WASHINGTON UTILITIES AND TRANSPORTATION COMMISSION

Washington State Dept. of Transportation)	DOCKET NO. TR-
_____)	
Petitioner,)	PETITION TO MODIFY HIGHWAY
)	RAIL GRADE CROSSING ACTIVE
vs.)	WARNING DEVICES
BNSF Railway Company)	
_____)	
Respondent)	USDOT #085445K
.....)	
_____)

The Petitioner asks the Washington Utilities and Transportation Commission to approve modification of highway-rail grade crossing warning signals.

WSDOT RAILROAD GRADE CROSSING DIAGNOSTIC TEAM REVIEW WORKSHEET*

Crossing Diagram

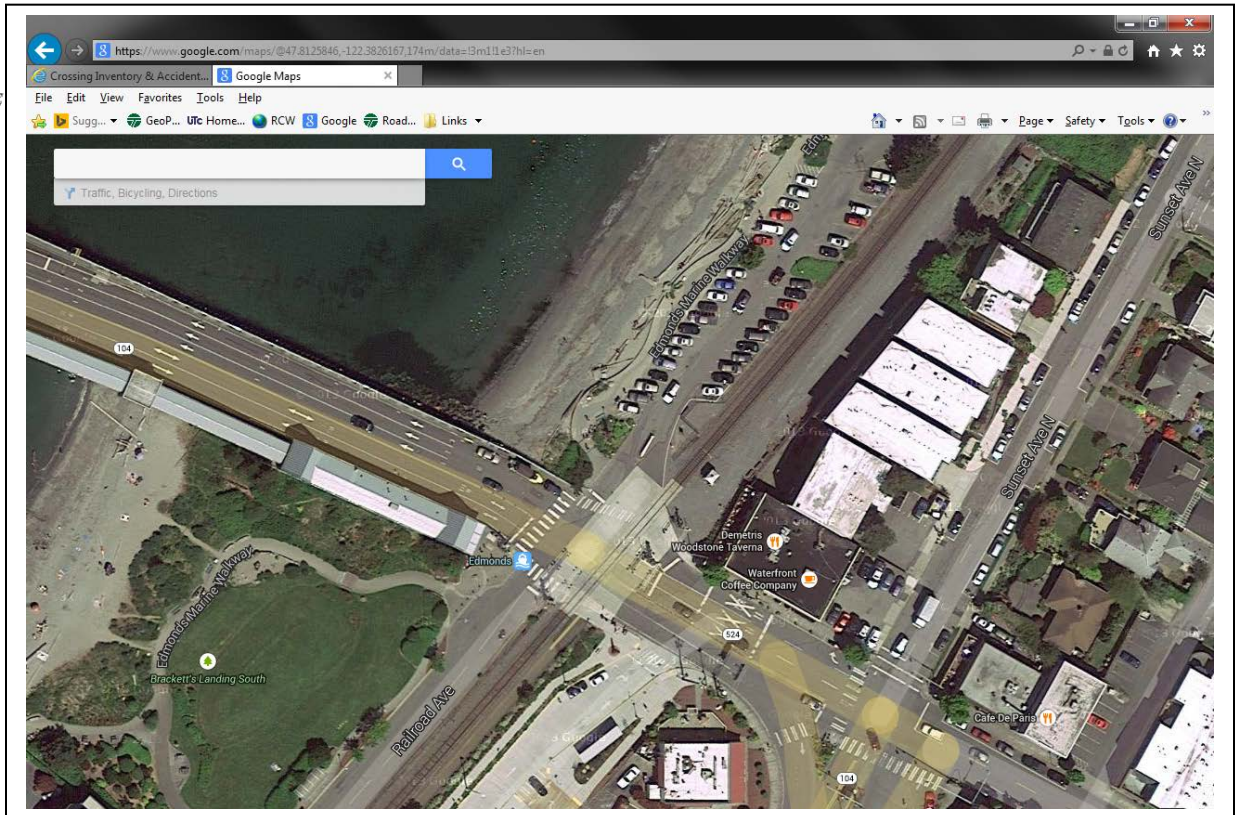
Currently Simultaneous Preemption, Per CTC study there is not enough clear time, there is a manual advance used by police – does it override preemption?

4/10/17 – Diagnostic Team was reconvened due to changes from BNSF in preemption timing requirements as outlined in the attached letter.

An additional site visit was conducted on October 16, 2017. Site visit was attended by UTC, BNSF, City and WSF staff and discussed hazards at the crossing that could be mitigated without updating preemption timing. WSF staff recounted a number of trip accidents near the tracks. On site observation noted high levels of pedestrian traffic.

Updated Recommendations: WSDOT: Install new Do Not Stop on Track (R8-8) signs on both approaches, install pavement markings from WSF approach. Update W10-1 (round railroad advance warning of crossing) signs for all approaches. Install R8-10A (Stop here) sign from both approaches (replacement of R10-6 WB (Stop here when red), remove non-standard sign on ferry terminal. Replace or reposition ped crossing ahead sign from traffic exiting ferry. Reduce tripping hazards for peds crossing track by improving road approach to crossing surface.

City: Reduce tripping hazards near tracks by improving sidewalk and ADA access.

BNSF: Upgrade railroad signals, including installation of install LED.
